# UPDATE PAPER

## Northern Area Planning Committee

**Northern Area Planning Committee – 9<sup>th</sup> July 2020  
Update Paper**

7. **20/00792/FULLN (REFUSE) 08.04.2020**  
SITE: Land at Sam Whites Hill, Valley Rise,  
**UPPER CLATFORD**

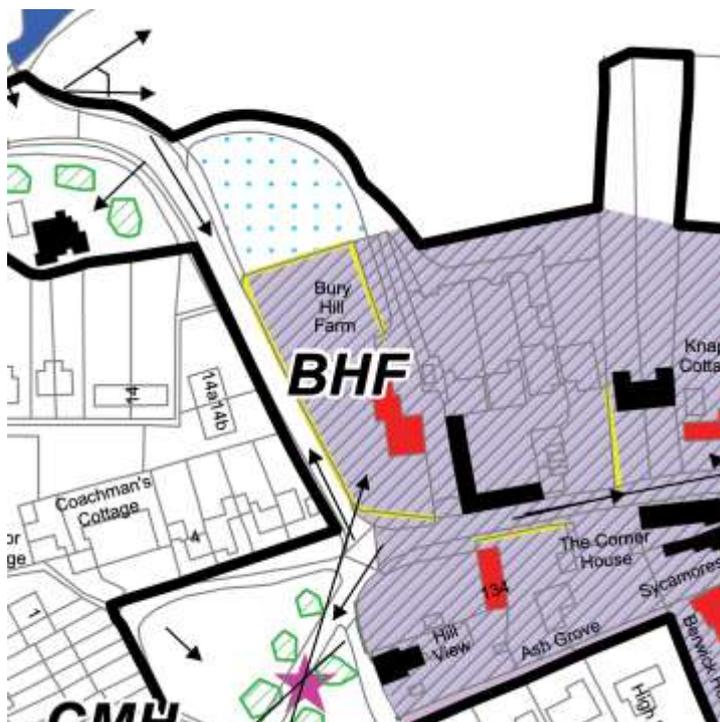
**The plot** The Heritage Statement shows a sequence of historical maps dating from 1733 to 1946. These illustrate a number of important points:

- The house and outbuildings with adjacent orchard were already well-established by 1733. The origin of the farmstead will pre-date this and potentially extends the link into early village history.
- Since at least 1733, the farmhouse has been surrounded by track/road to the west and south, and outbuildings to the east. Its sole relationship with surrounding land has been with the plot to the immediate north and this is clearly shown on every map provided to 1946; indeed, it is clearly evident today.
- The northern boundary of the plot was already established by 1841, and possibly as early as 1734.

- The Heritage Statement comment that "there was clearly an historic relationship between the farmhouse and the former garden area" is therefore

correct; however, to follow with “but it is considered that this relationship is not of such importance, given the fact that the land has little evident domestic garden character today” not only undermines the historic mapping described above but fails to explain that the ‘domestic garden character’ has been destroyed by the proposer’s neglect only since the plot changed ownership in 2016 and could, with care and imagination, be restored. The photographs below clearly show the garden character and demolished historic wall (left photo) and the view of the plot today exposed by the removed section of wall. These serve to show the important relationship that the proposed scheme threatens.
